**Planning Board Meeting Agenda
Brunswick Town Hall
85 Union Street – Council Chambers
Tuesday, February 10, 2026 @ 6:00 PM**

4. **Case No. 25-059 – MaineHealth Mid Coast Cancer Center Renovation:** The Planning Board will review and act upon a **Site Plan Amendment** application submitted by Pine Tree Engineering on behalf of the property owner, Mid

DRAFT FINDINGS OF FACT SKETCH PLAN MAJOR DEVELOPMENT REVIEW PLANNING BOARD

Overall Site Plan

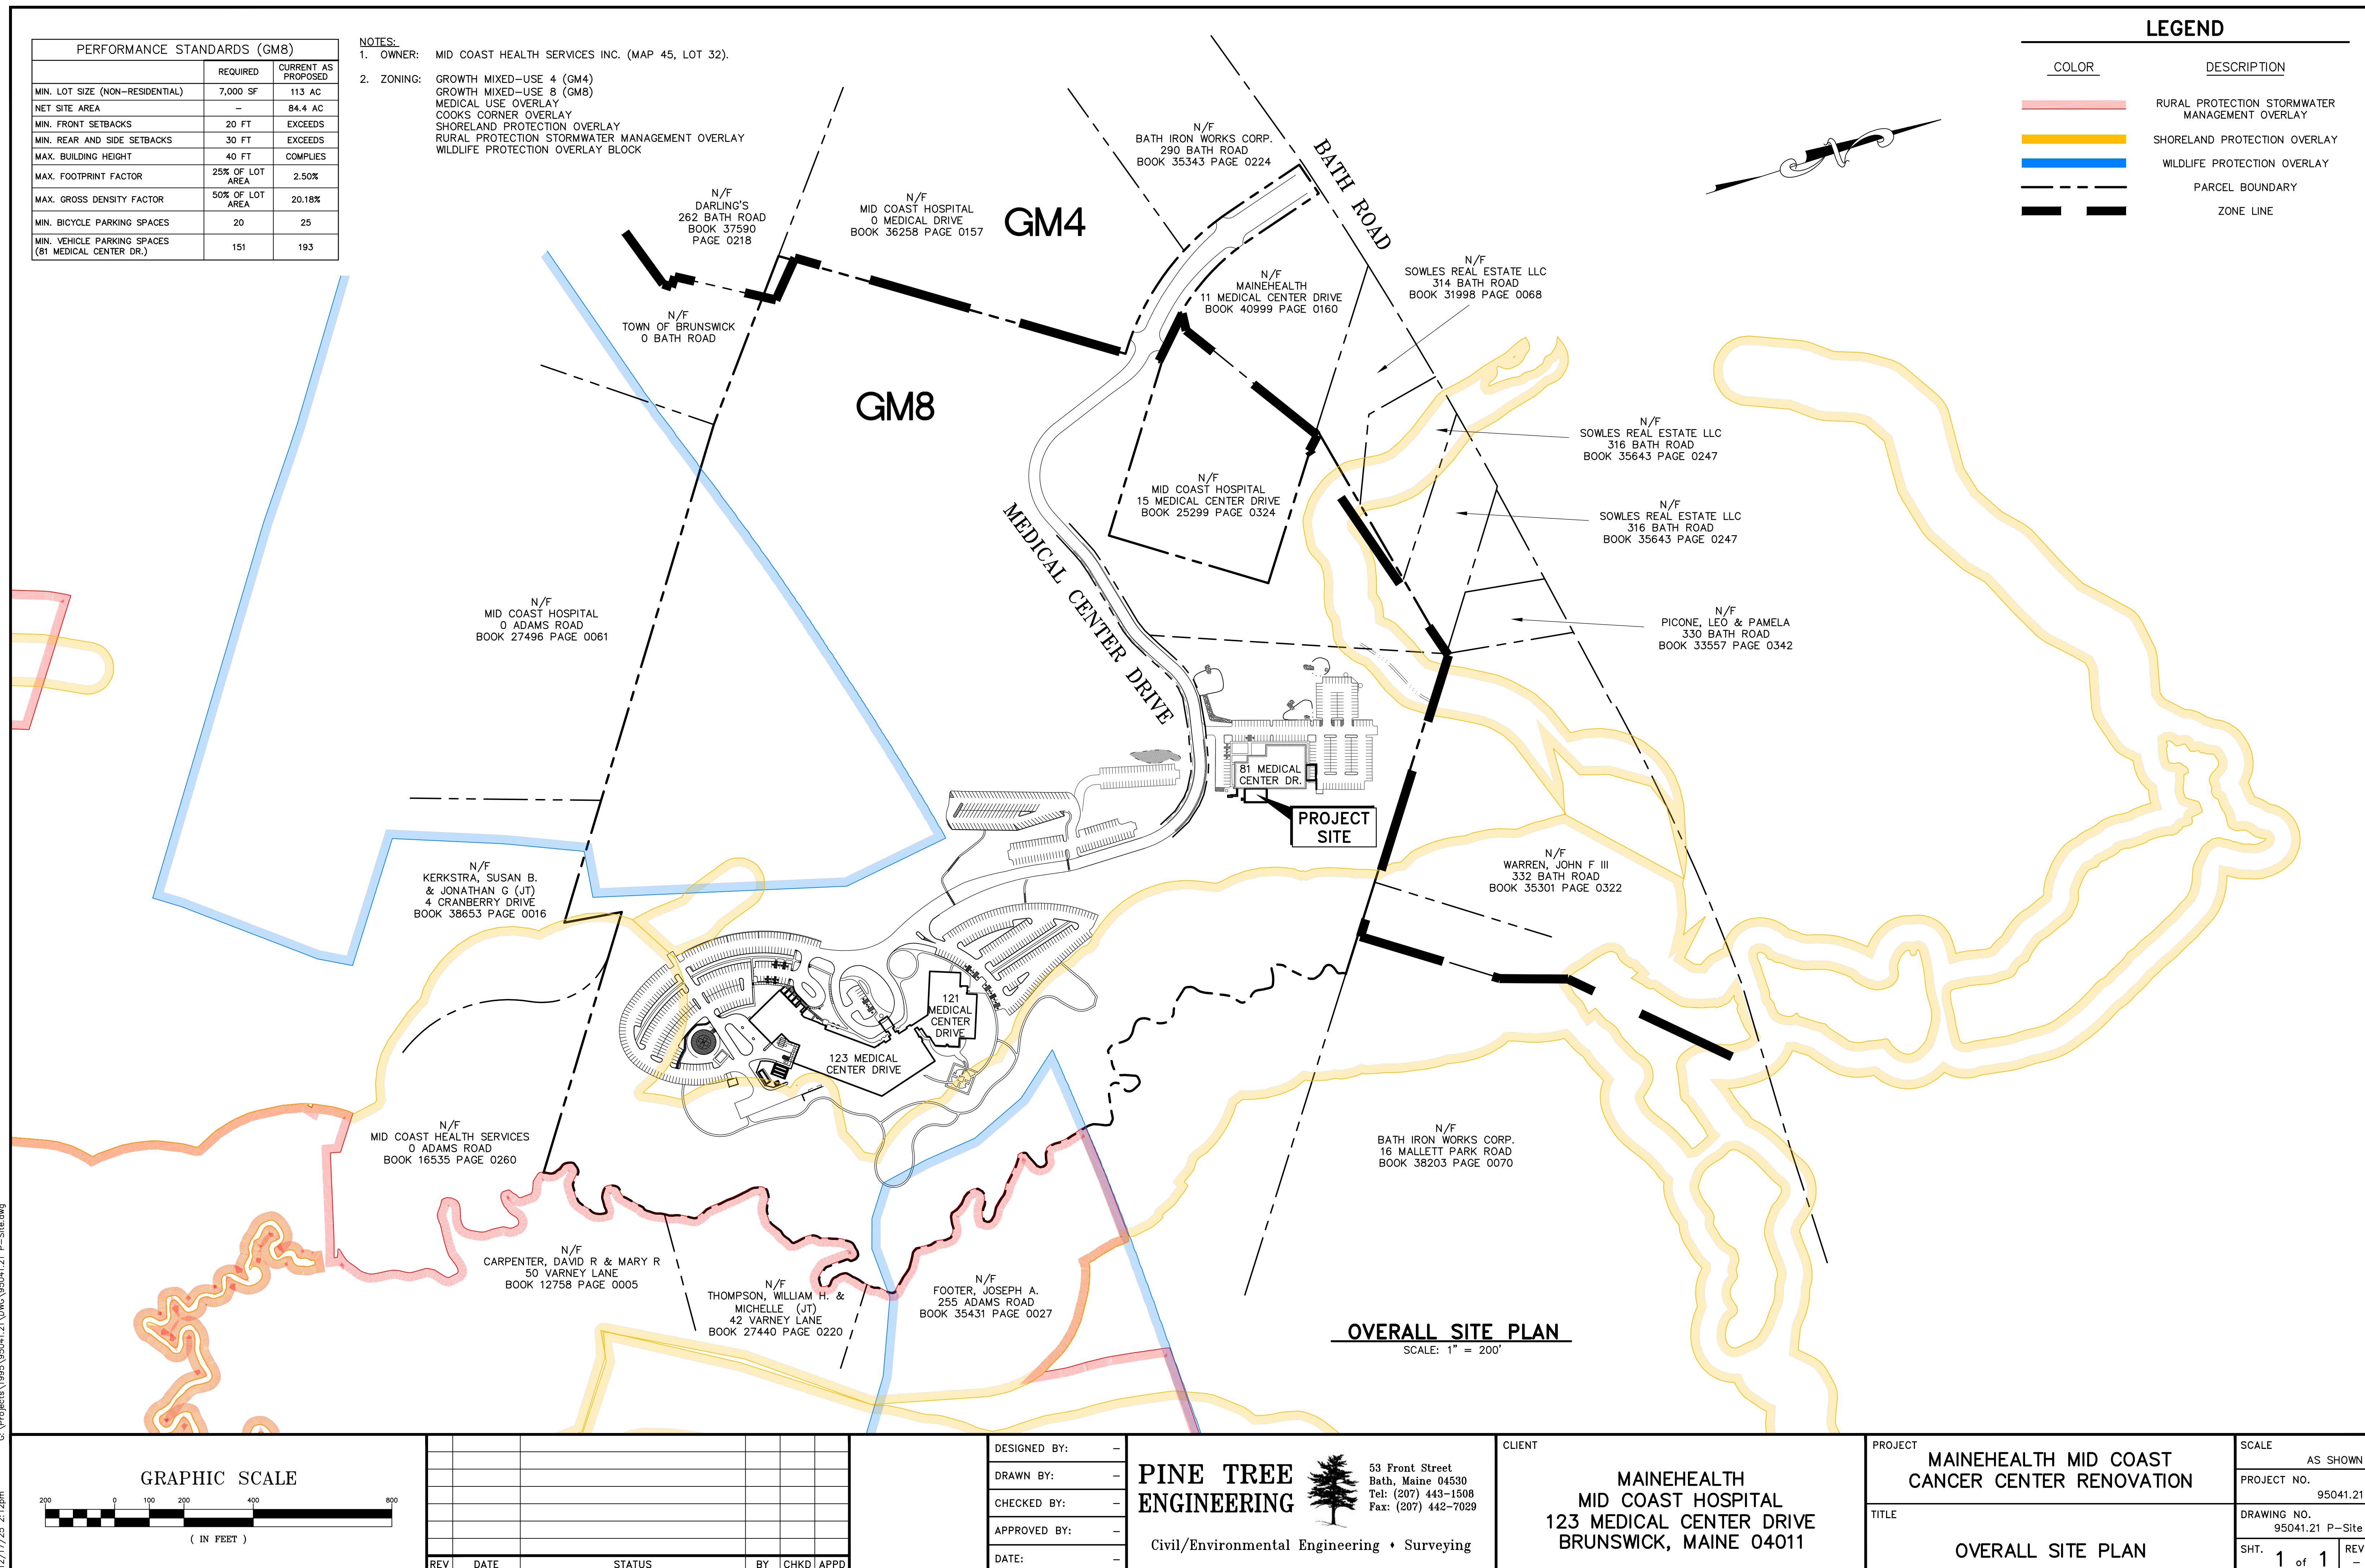
9. Add table of requirements plans (dimensional standards, density standards)	See Exhibit 2: Overall Site Plan.
10. Create overall site plan that shows entire parcel to be included in the application	See Exhibit 2: Overall Site Plan.

12. In item #10 above, include parking SF of building, and total parking	See Exhibit 2: Overall Site Plan.
13. Provide wetland delineation report	See Exhibit 9: Chapter 4 Development Standards, Section 4.3.1. for the updated response. The wetland delineation report is on file with the Town from previous applications, as this is an amendment.

14. Provide updated mapping, including Town overlays. This will be shown in #10 above.	See Exhibit 2: Overall Site Plan.
15. Reach out to Maine Natural Areas Program and IF&W for existing sensitive/threatened habitat/species on-site. Email is sufficient	See Exhibit 7: Environmental Review.

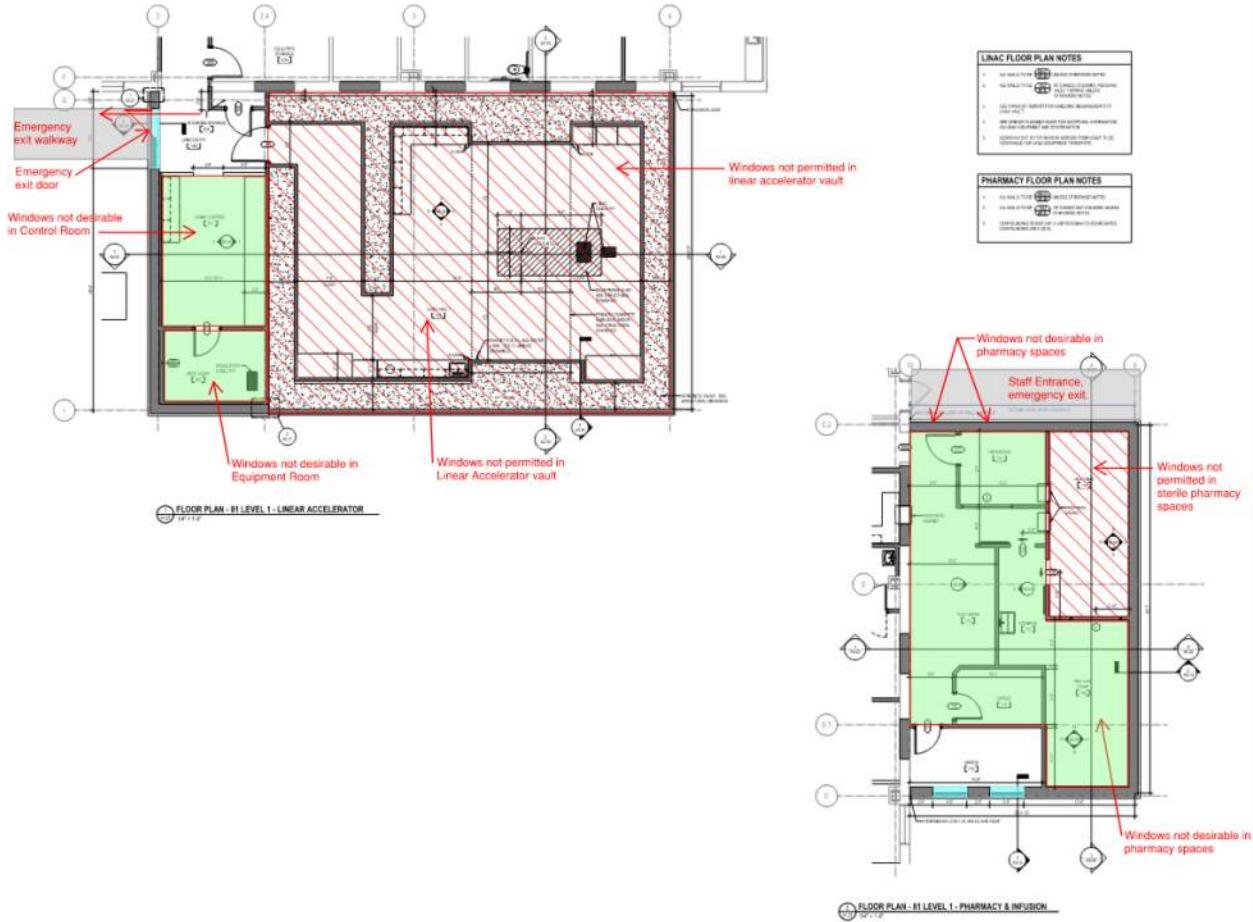
3. Add ornamental grass along parking lot side of pharmacy, near bollards	See Section B-B on AS3.00 Civil Details
Architecture Comments	
4. Review Cooks Corner Design Standards, specifically Section 3.4 Fa?ade Requirements, and within 3.4.j.	See Exhibit 8: Cook's Corner Design Standards Narrative.
Engineering Comments

By: 
Gary Parrotta, Member

Town Of Brunswick
Planning & Development
85 Union Street
Brunswick, ME 04011
